Docket Nos. 50-277/278

SUBJECT: TRIP REPORT FOR PEACH BOTTOM SITE VISIT
REGARDING WRONG UNIT/WRONG TRAIN EVENTS

WRONG UNIT/WRONG TRAIN EVENTS AT PEACH BOTTOM

FIGURE 3 ENGRAVED LABELS AT PEACH BOTTOM

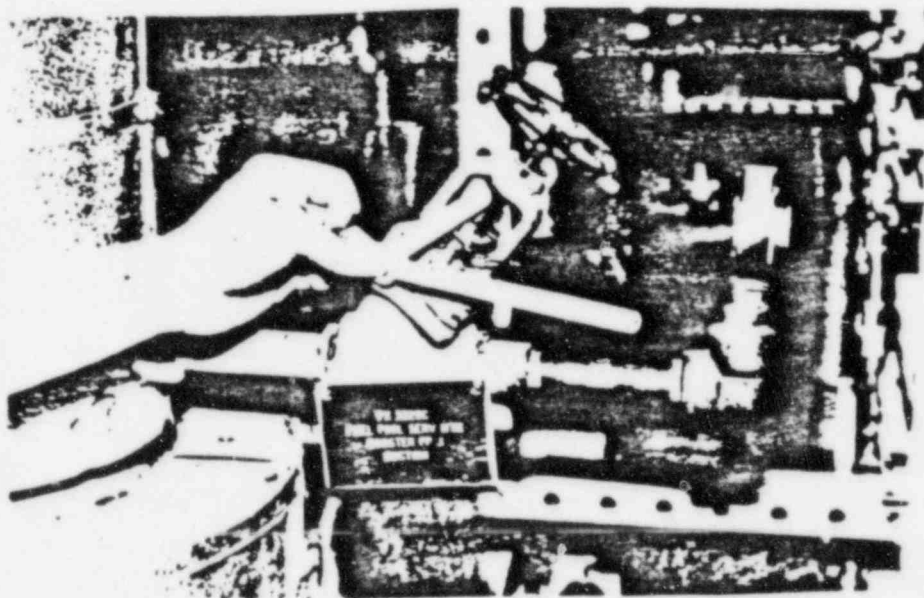
Component labeling at Peach Bottom currently employs plastic-type engraved labels, hung from a metal chain for valves, that provide unit, system, and item designation. The licensee's staff indicated that these labels do tend to get brittle and dirty (see Figure 3). Peach Bottom is currently in the process of installing CEMS labels (discussed above) which are expected to rectify these concerns (see Figure 4). However, the currently used CEMS labels are susceptible to high temperature degradation, a problem the licensee is working to address. The NRC staff's limited tour of the Peach Bottom facility found most valves and open components labeled with the exception of a group of valves (see Figure 3).
